PRELIMINARY DRAINAGE REPORT
for
THE COMMONS AT FALCON FIELD

PCD FILE NO. SP-232

Drexel, Barrell & Co.
101 Sawatch Street, #100
Colorado Springs, CO 80903
Contact: Tim McConnell, P.E.
(719) 260-0887

DR2

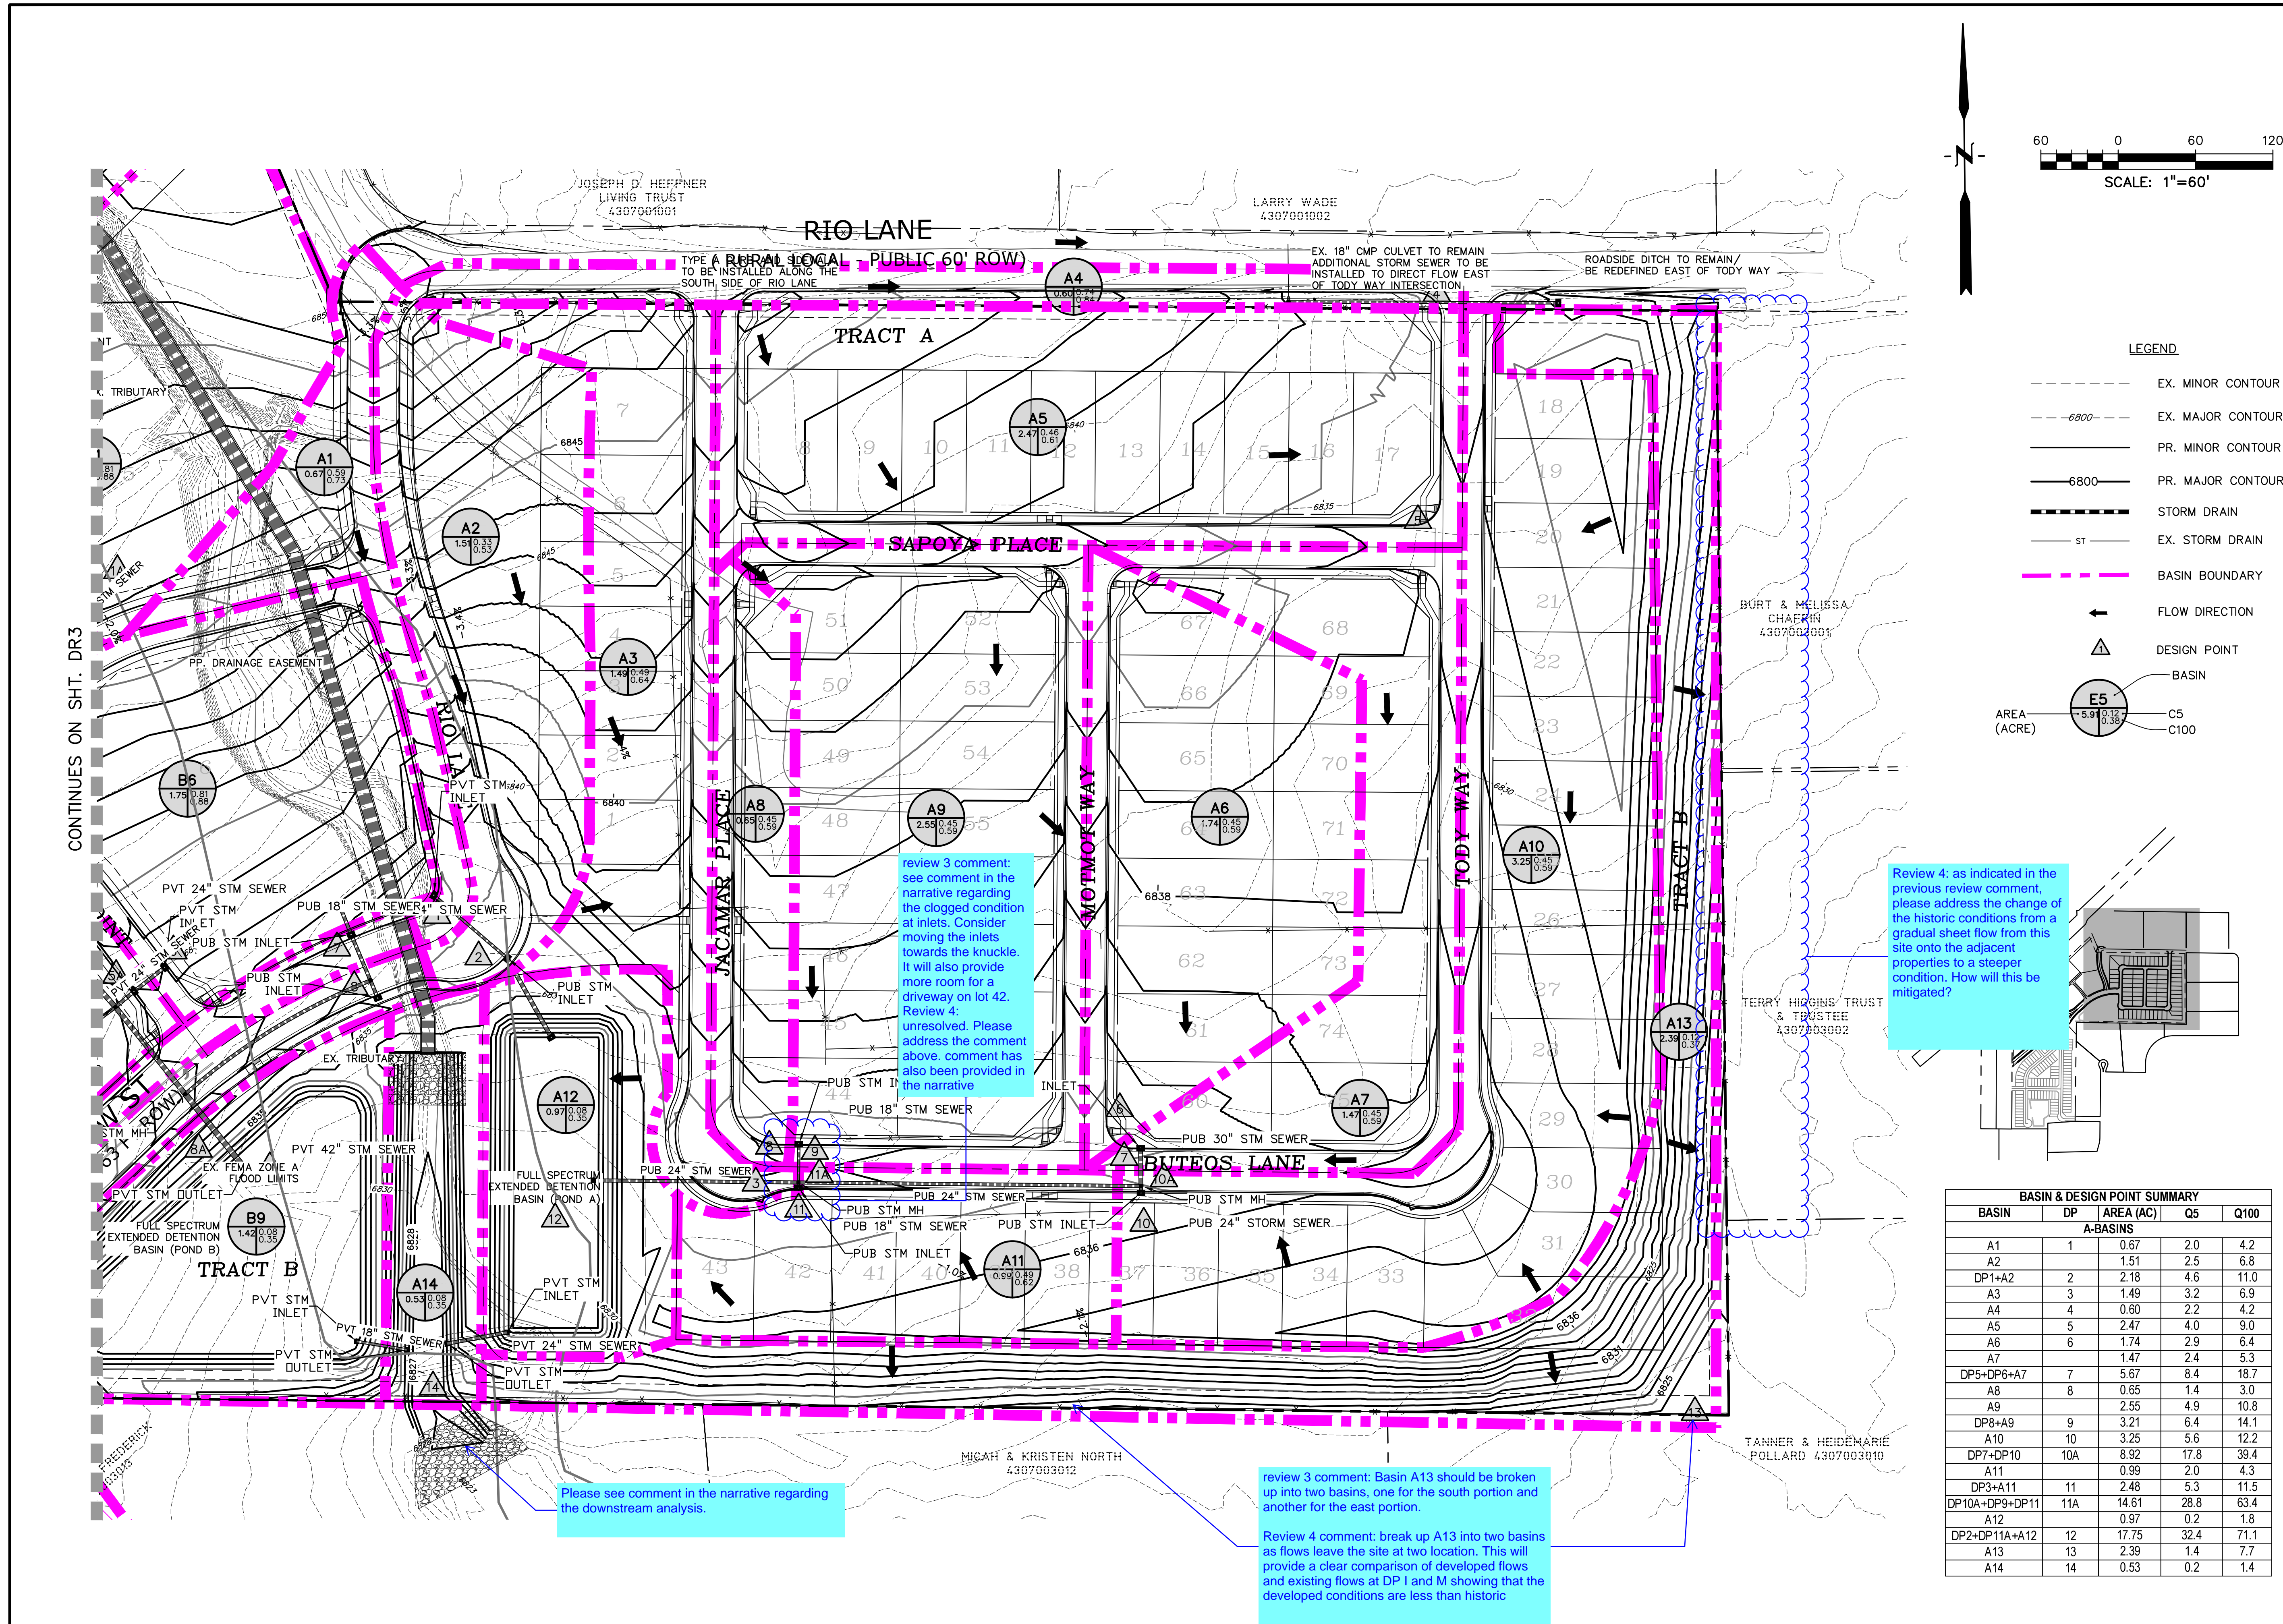
Review 4 comment: break up A13 into two basins as flows leave the site at two location. This will provide a clear comparison of developed flows and existing flows at DP I and M showing that the developed conditions are less than historic

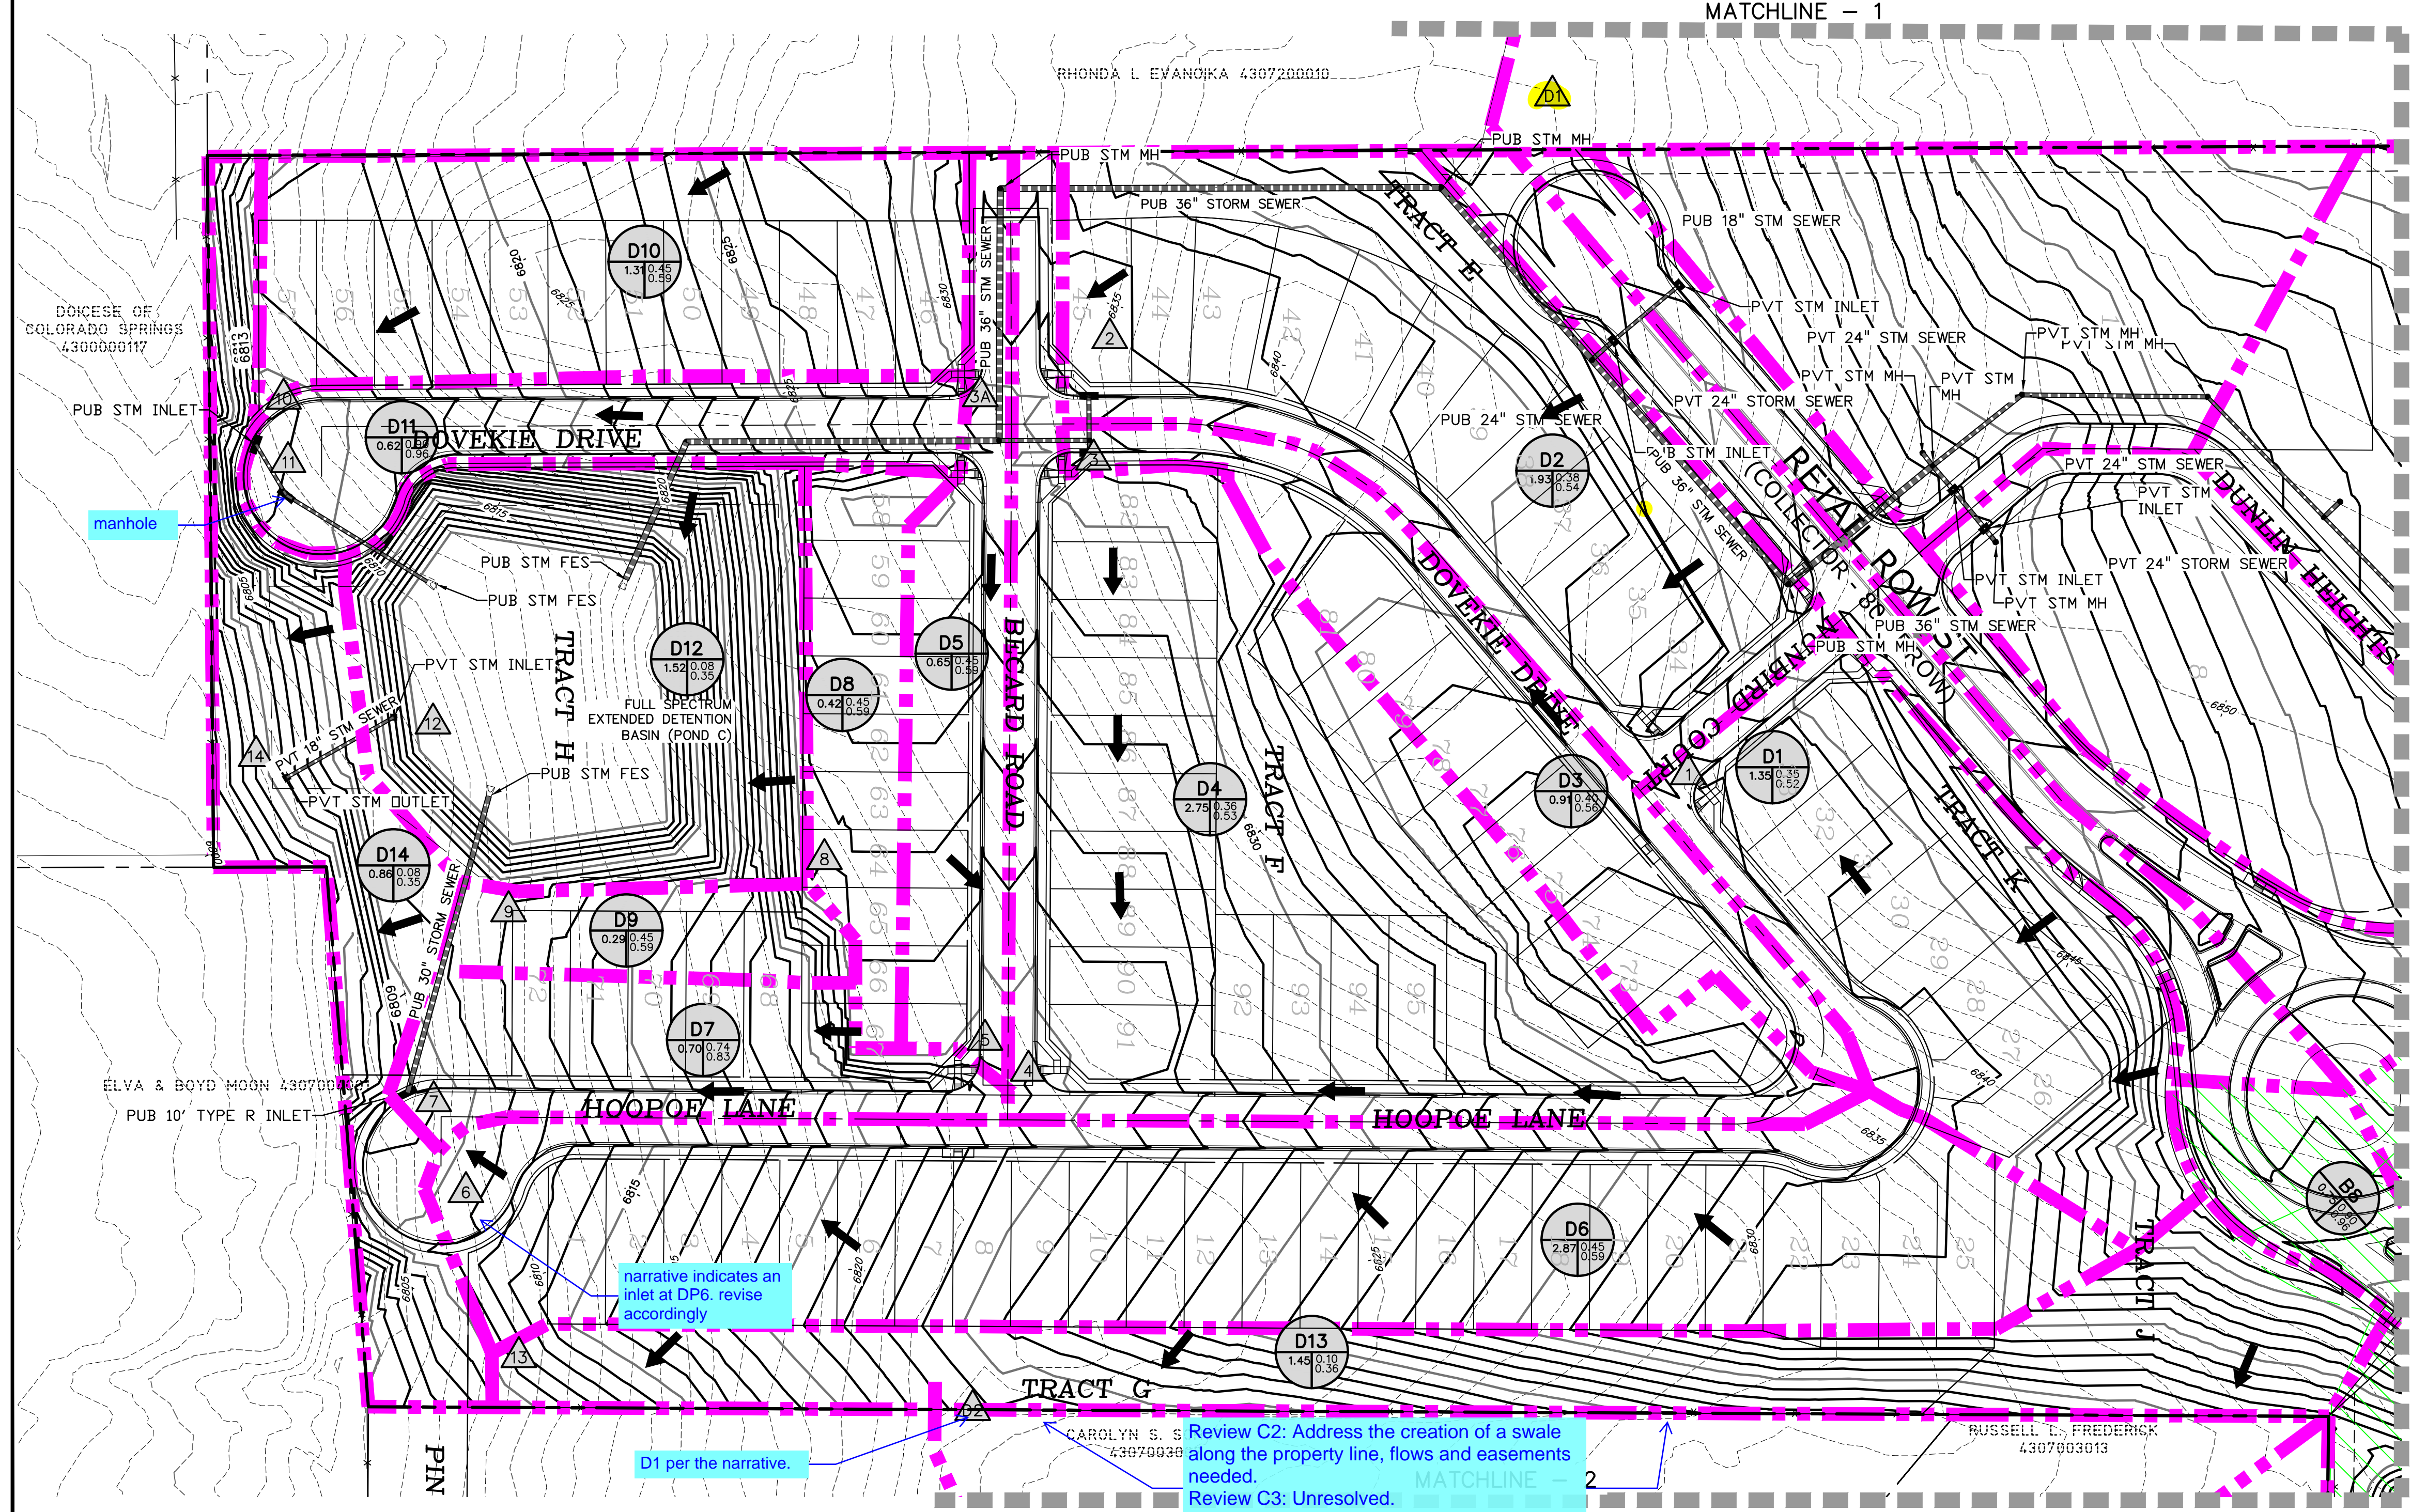
narrative indicates an inlet at DP6. revise accordingly
